The Partial Amendment to Announcement of Specifying Details of the Safety Regulations for Road Vehicles

Test cycle and limit values under WMTC mode

3. Driving Schedule

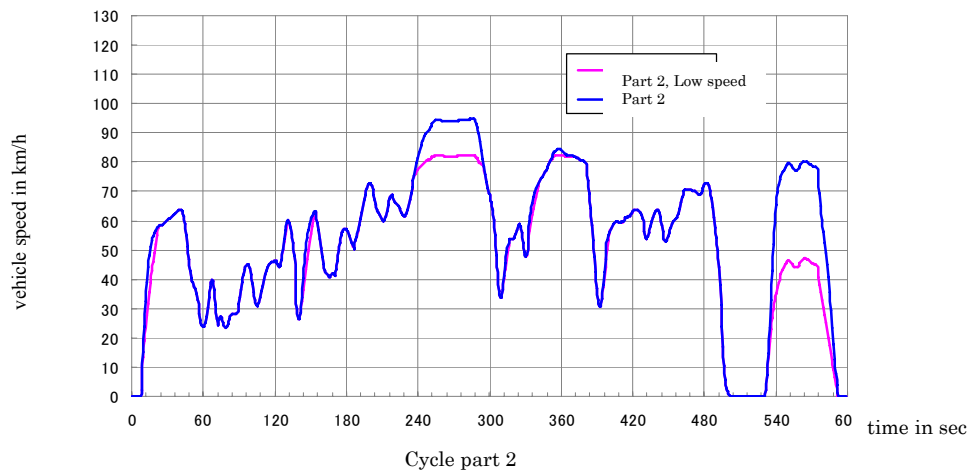
The WMTC (World-wide Motorcycle Test Cycle) gtr established in the World Forum For Harmonization of Vehicle Regulations (UN/ECE/WP29) will be introduced to national regulations as a new test cycle. (more details; see Appendix)
